City of El Paso — Plan Commission — 08/23/2018

PZRZ18-00015 Rezoning REVISED

REQUEST: To rezone from R-3 (Residential) to C-1 (Commercial) to allow for

Conceptual Site Plan

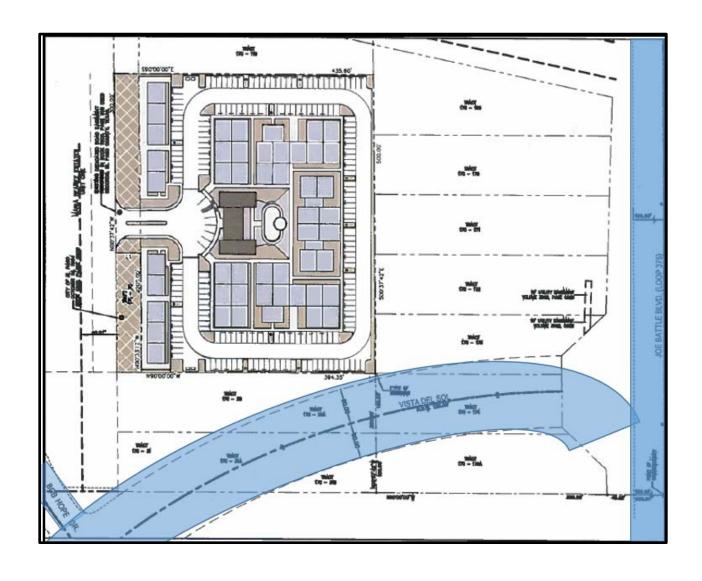
- 1. Add note on site plans: All Storm-water runoff discharge volumes shall be retained within this lot's limits (DSC, 19.19.010A and DDM, 11.1)."
- 2. Show existing and proposed drainage patterns, ponding area locations, and label all drainage structures.
- 3. Add current FEMA FIRM flood zone information to general notes.

Waste storage area(s) for any dumpsters will need to be identified on the plans, and will need enclosures to keep them screened from surrounding R-3. The enclosures will not be required if there is a six-ft. rock wall between the C-1 and R-3 parcels.
